## Determination 2021/008

### Regarding the authority's decision to issue a code compliance certificate for a new dwelling at 19A Te Atatu Road, Auckland

**Figure 1: Approximate site plan**

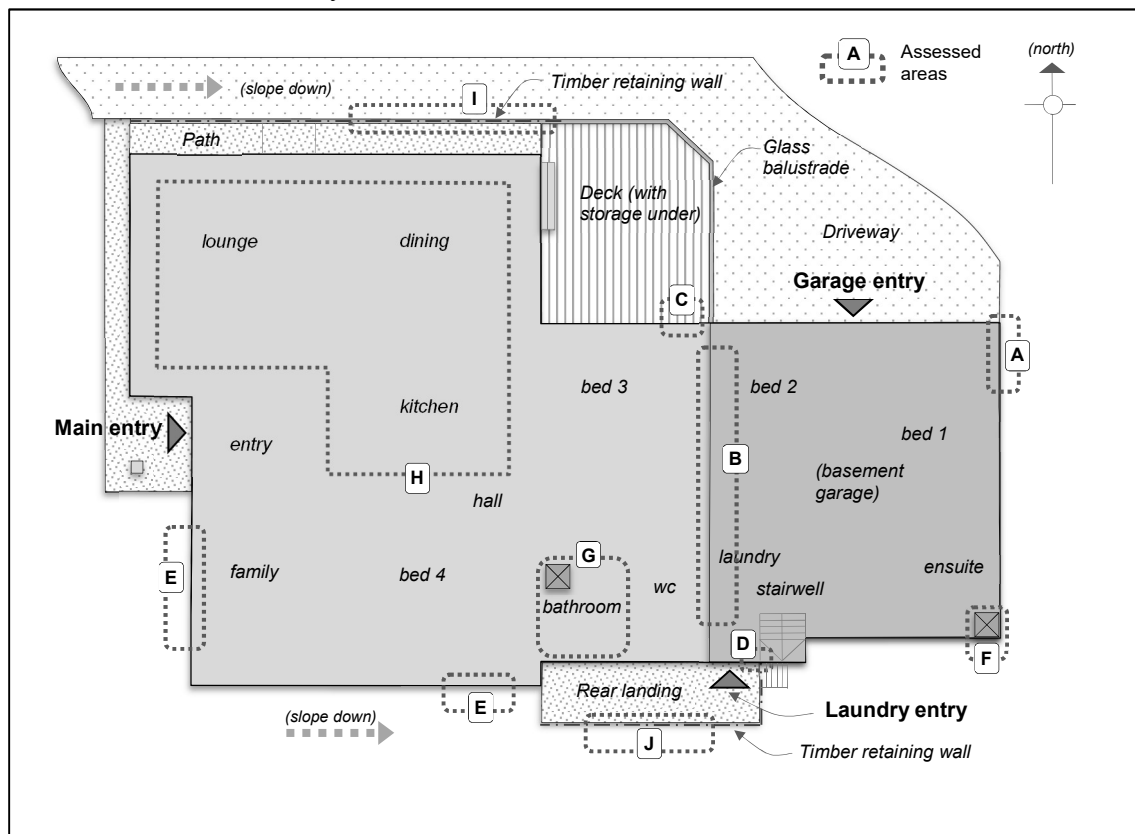
5.2.2 The structural expert's opinions included the following (in summary, with Areas referenced as per Figure 1):

- The garage masonry walls:
  - the basement masonry walls (other than the west wall which was not visible) have been plastered on both faces, which is unusual;

- some random minor cracking to the plaster is visible;
  - some of the exterior plastering has been taken too high, partially blocking the brick veneer bottom course weep holes and restricting drainage;

- the weep holes were not installed at consistent centres; and
  - vertical cracks indicate plastered over "control joints" typically installed at 6m centres in non-critical locations that do not affect code compliance.

- At the garage west retaining wall (Area B):
  - the full height masonry retaining wall cannot be viewed, as a lined partition has been constructed in front of it;

- it is understood the partition was installed since the code compliance certificate was issued, concealing tanking membrane remedial works;
  - the area partially excavated behind the garage masonry retaining wall (Area C) exposed under-slab hardfill comprised of broken concrete, bricks, and general rubble that would not necessarily compact readily and could result in slumping to the concrete slab, affecting compliance with Clause B1; and

- At the perimeter foundations (Area E):
  - the lack of any visible cracking in the brick veneer and foundations indicates foundation settlement has not occurred;

- exposed bottom edge plaster lines indicate settling of the ground outside the building footprint, which does not affect compliance with Clause B1;
  - inadequate concrete vibration observed in some areas appears to be cosmetic and assuming adequate steel reinforcing cover, does not affect compliance with Clauses B1 and B2;

- if sub-floor material "leakage" at steps in the perimeter strip foundations continues, the concrete floor slab will be inadequately supported within 50 years, affecting compliance with Clauses B1 and B2; and

5.3.1 The building surveyor provided opinions on the compliance of the garage and the ground clearances regarding external moisture, the shower installation, and whether the kitchen and living room floors were sloping (in summary as follows, with Areas as per Figure 1):

- At the garage east masonry wall (Area A):
  - there is widespread mould growth and staining on the garage interior plaster, most intensely around the vertical control joints;

- cracking to the exterior plaster is likely due to workmanship issues and exacerbated by water ingress getting behind the plaster (confirmed through dye testing); and

- water ingress has likely occurred through cracks in the exterior plaster and from water ingress at the brick veneer drainage slots, finding the path of least resistance through the vertical control joints and spreading out from there, breaching Clause E2.

- At the garage west masonry retaining wall (Area B):
  - it was not possible to directly check the adequacy of waterproofing, drainage or fill; and
  - no direct drainage line was visible in the nearby cesspit.

- At the garage south stair masonry retaining wall (Area D):
  - water damage was visible to the stair timber and wall linings below a large gap at the junction between the rear landing and masonry wall

- the rear landing has moved away from the building allowing water from a constantly dripping overflow and rain to discharge down the insufficiently waterproofed masonry wall.

- At the ground clearances (Area E):
  - soil levels have been built up against the cladding in some areas;
  - about one-third of clearance measurements were well below those set out in the building consent and the Acceptable Solution<sup>6</sup> E2/AS1 in effect in 2012;

- the south elevation ground near the building appeared to have been washed away, exposing the foundation and slab edge; and
  - no water ingress was observed related to the ground clearance issues.

- At the ensuite bathroom shower (Area F):
  - the shower tray has been installed incorrectly out of plumb and without the required upstand to the wall lining, resulting in mould growth, significant water ingress and damage to timber framing and internal linings; and

- the as-built upstand detail is reliant on sealant and is not in accordance with the consented drawings or the Acceptable Solution E3/AS1 current at the time.

- At the main bathroom shower (Area G):
  - the shower tray has been installed incorrectly without the required upstand to the wall lining, resulting in mould growth, water ingress, damage to wall linings and likely damage to timber framing, breaching the performance requirements of Clause E3;

- the as-built upstand detail is reliant on sealant and is not in accordance with the consented drawings or the Acceptable Solution E3/AS1 current at the time; and

- the installation of the timber trim between the shower glass and bathtub was not waterproofed and showed signs of deterioration.

- At the kitchen floor slab (Area H):
  - the kitchen overlay flooring showed some hollowing toward the edge and falls outside acceptable levels, both considered workmanship issues; and
  - settlement of the concrete slab was not observed.
- At the living room floor slab (Area H):
  - four indicative measurements over the carpeted area suggested levels outside or close to acceptable tolerances;
  - a single measurement on the tiled surface showed a measurement outside acceptable tolerances;
  - given the measurement inaccuracies and amenity assessment, the falls are assessed as subjectively ‘just acceptable’ and the result of workmanship issues; and
  - settlement of the concrete slab was not observed.

- the garage south stair masonry retaining wall does not comply with Clause E2.3.2, and further investigation would be required to establish the performance of other areas of the garage masonry retaining walls;
- the main bathroom shower and ensuite shower do not comply with Clause E3.3.6 with regard to the lack of wall upstand; and
- though the perimeter foundation currently complies with Clause B1, work is required to prevent “leakage” of the hardfill to maintain the structural performance of the perimeter foundation for the required durability period (Clause B2.3.1 as it applies to Clause B1).

6.2.4 I am of the view that the limited ground clearance from built-up soils and the partial excavation behind the garage masonry retaining wall (Area C) are matters of maintenance.
